Historic Preservation Board

Wednesday, November 15, 2023 at 5:00 PM

- i. Administrative Appeal of Certificate of Appropriateness for Alterations to Noncontributing Garage; 14 ORCHARD STREET; William & Jean Bennett, Appellants. Plan Number: HPAR-002615-2023.

**STAFF MEMORANDUM
HISTORIC PRESERVATION PROGRAM
PLANNING AND URBAN DEVELOPMENT**

DRAWING NUMBER
3
A3.10

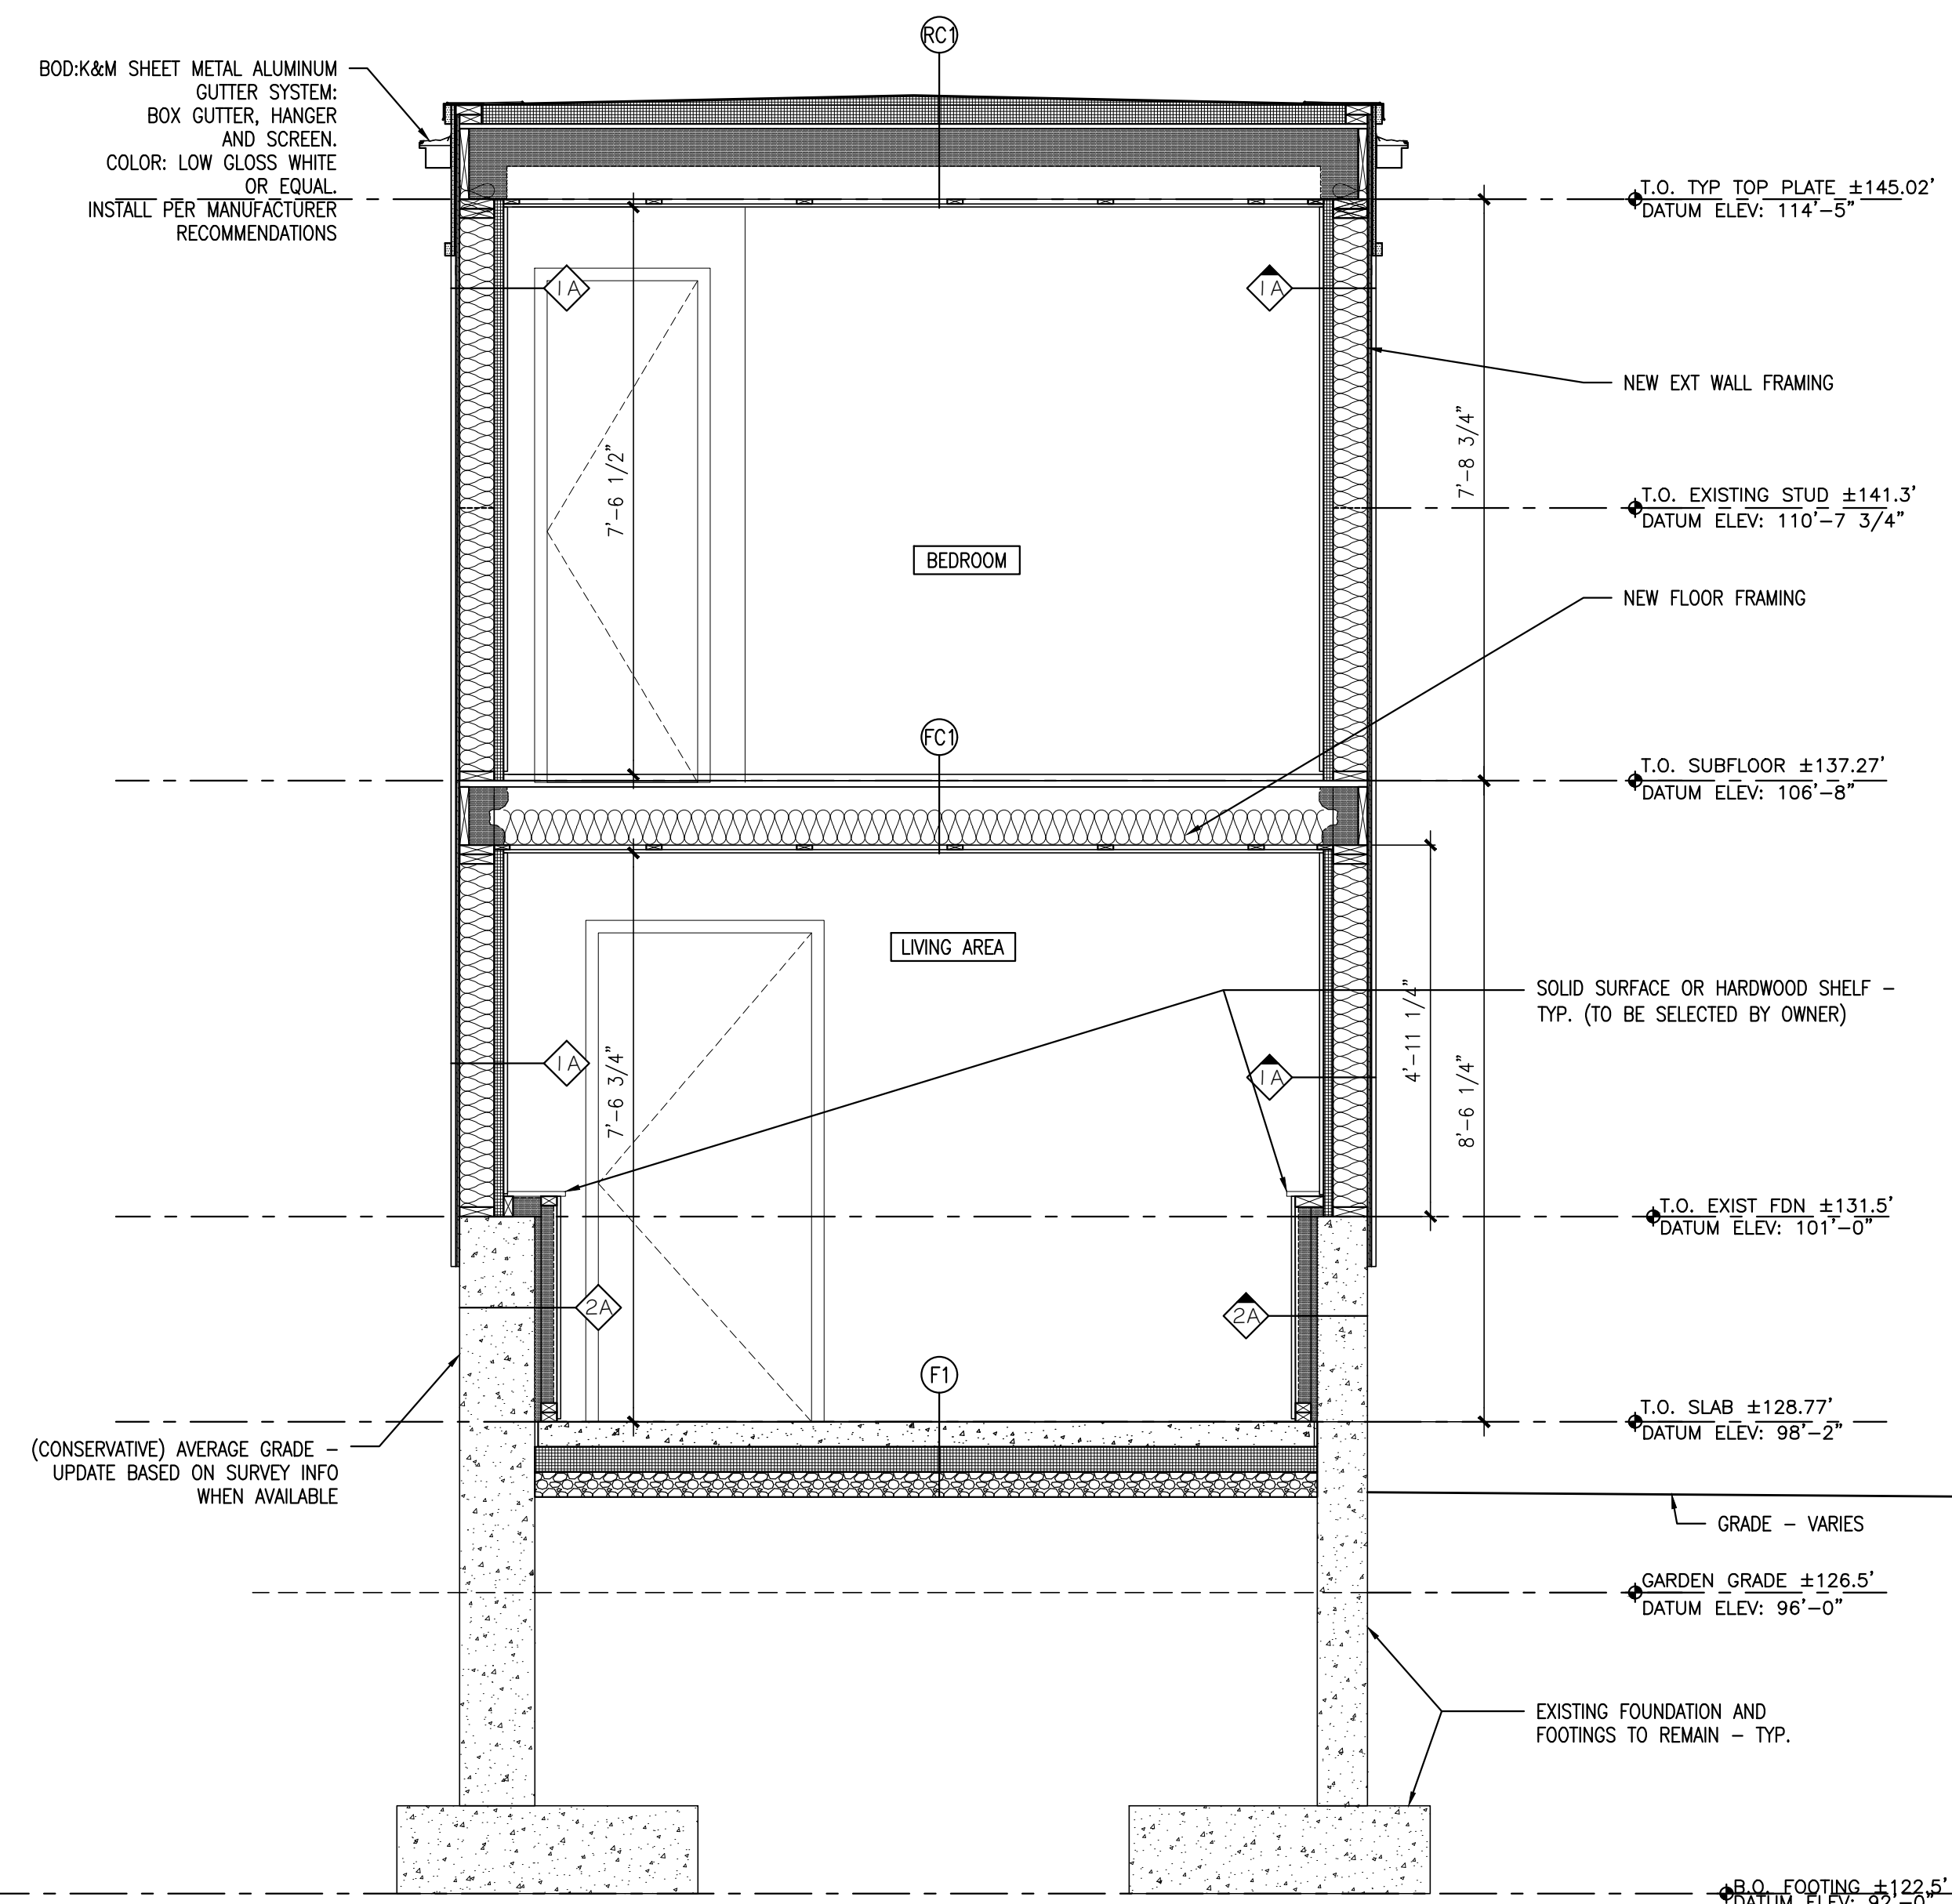
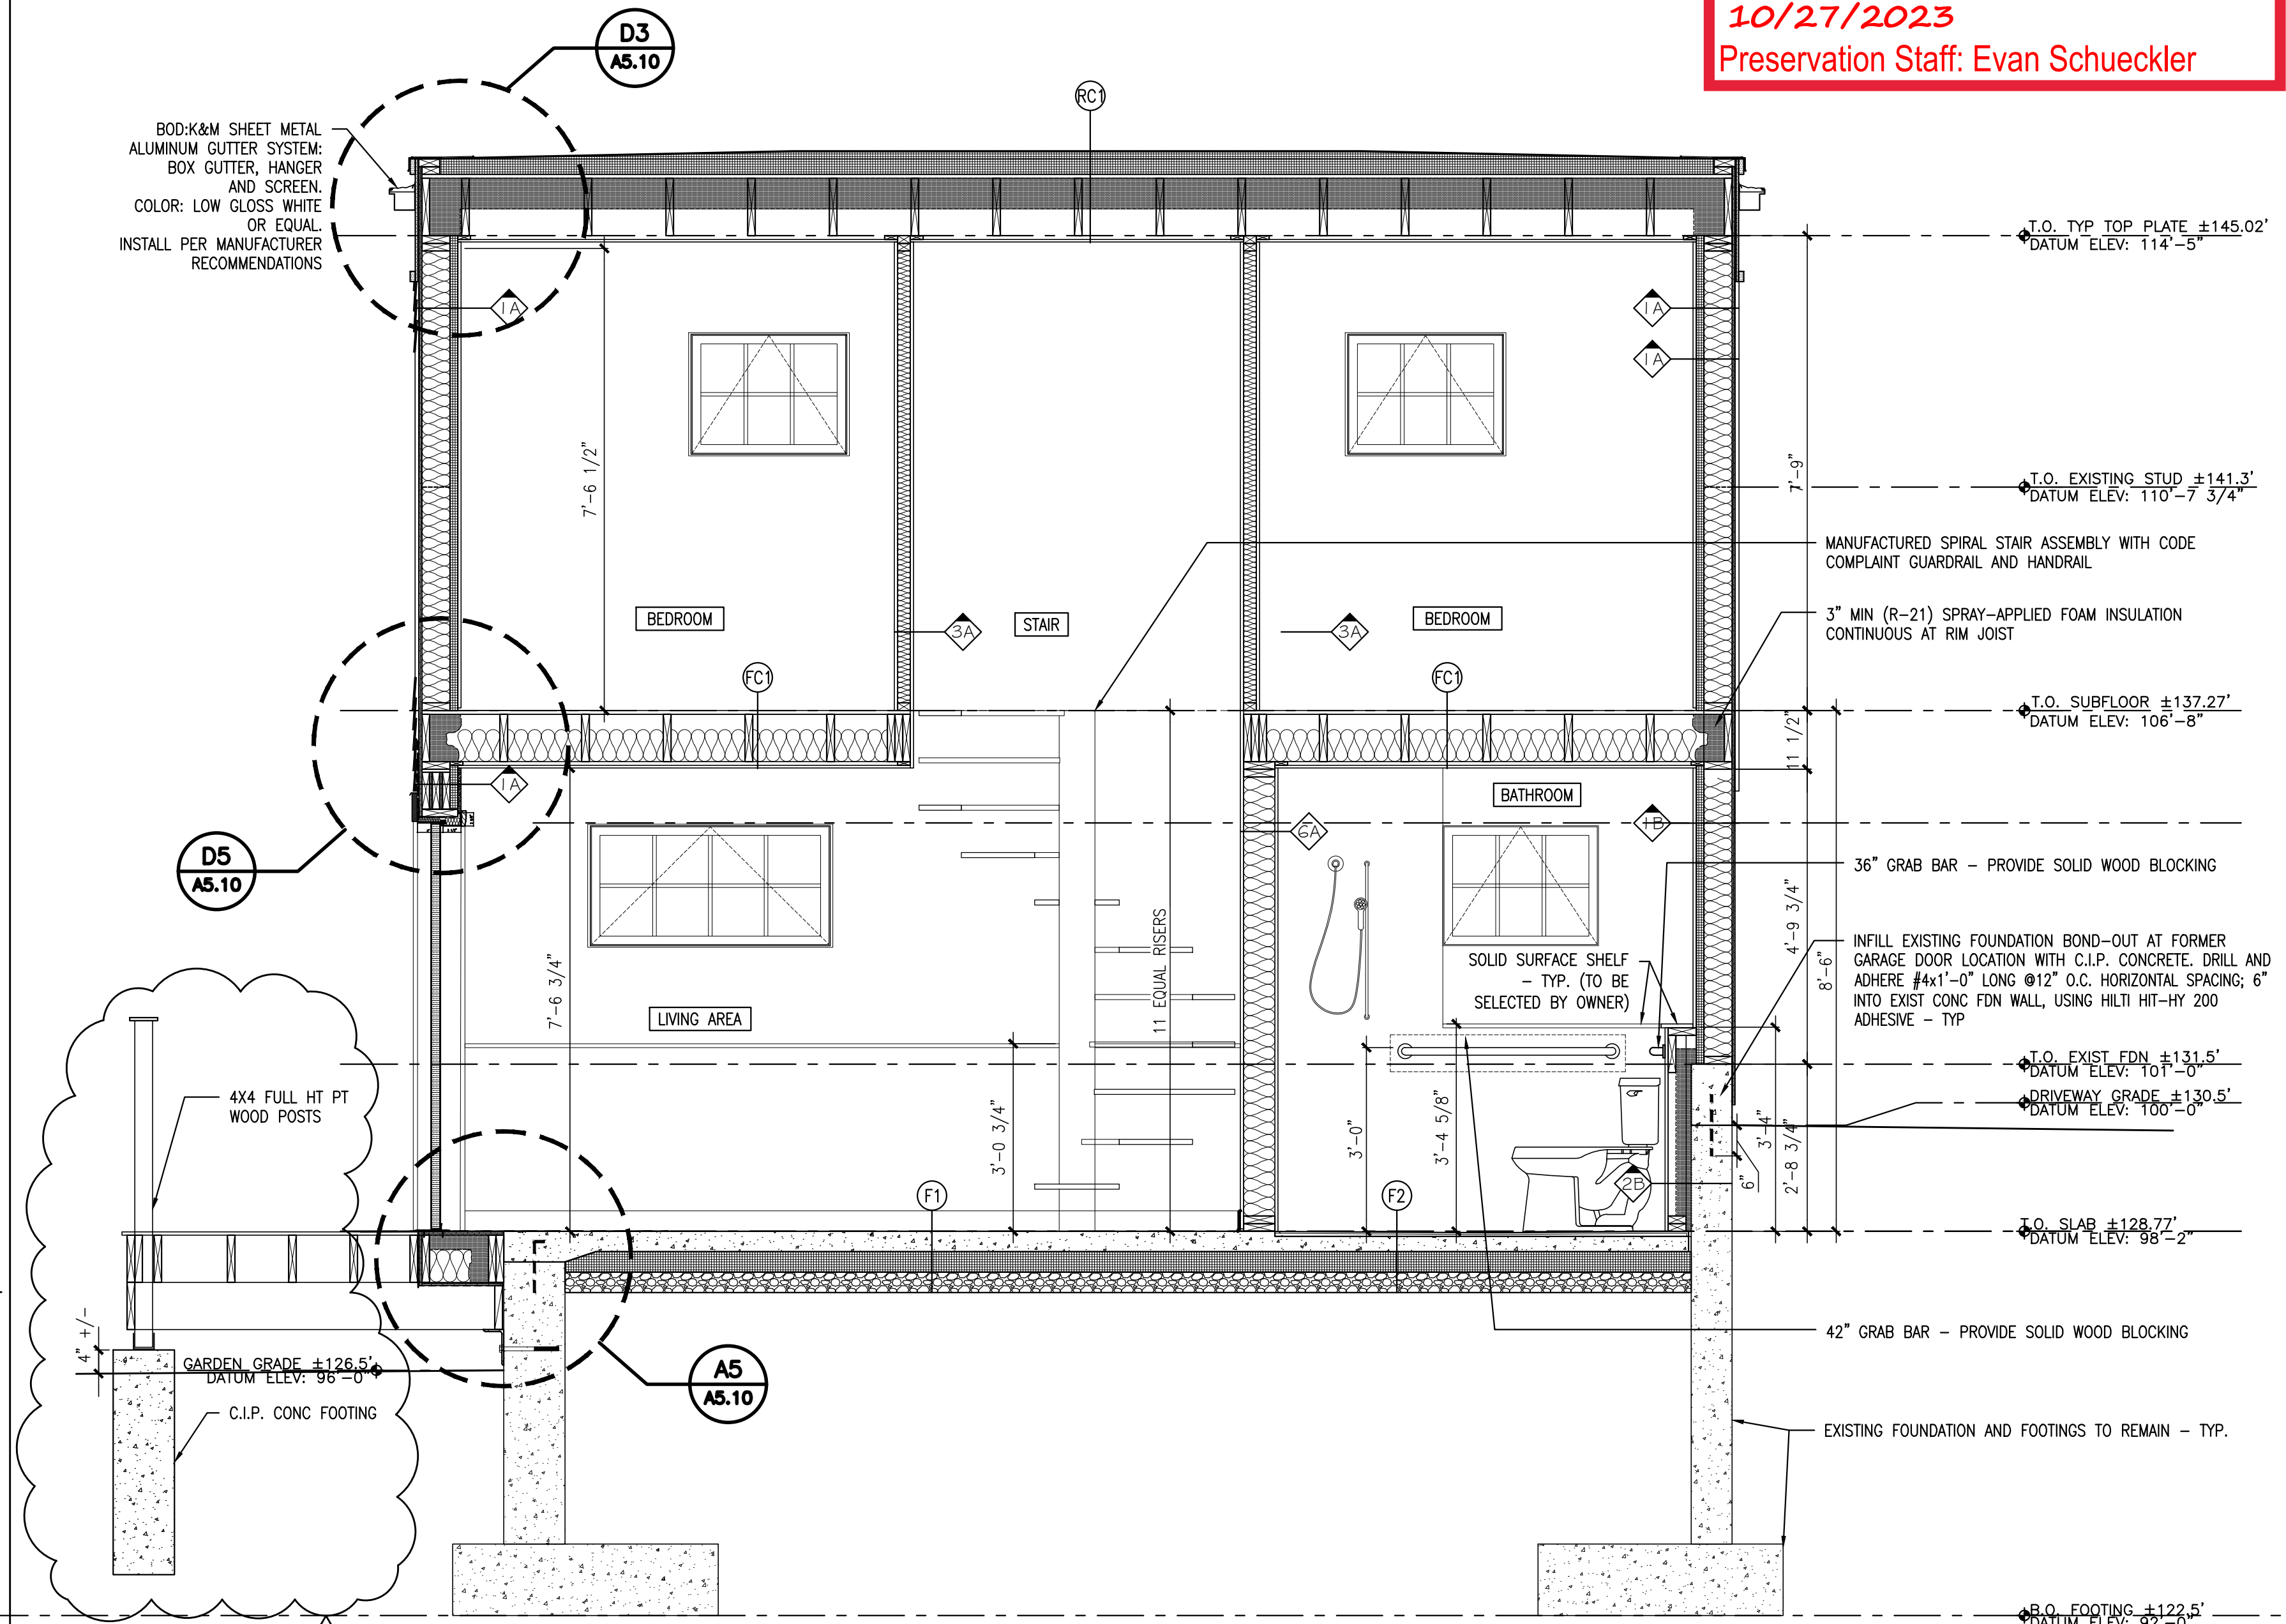
- △ REVISED SUBSTANTIALLY TO COORDINATE DATUM ELEVATIONS, FOR UPDATED RAMP AND BALCONY LAYOUT, FOR UPDATED BEDROOM WINDOWS, AND TO MAINTAIN EXISTING FOUNDATION. NOTED EXTERIOR CHARACTER AS DESIGN OPTION A FOR HISTORIC APPROPRIATENESS REVIEW.
- △ REVISED TO INCORPORATE COMMENTS FROM HISTORIC APPROPRIATENESS REVIEW.
- △ REVISED TO COORDINATE ELEVATIONS, FOR UPDATED STAIR AND BALCONY LAYOUT.

1. REVISED TO COORDINATE ELEVATIONS; ADDED FRAMING DETAILS
2. REVISED TO INCORPORATE COMMENTS FROM HISTORIC APPROPRIATENESS REVIEW.
3. REVISED FOR UPDATED STAIR AND BALCONY LAYOUT.
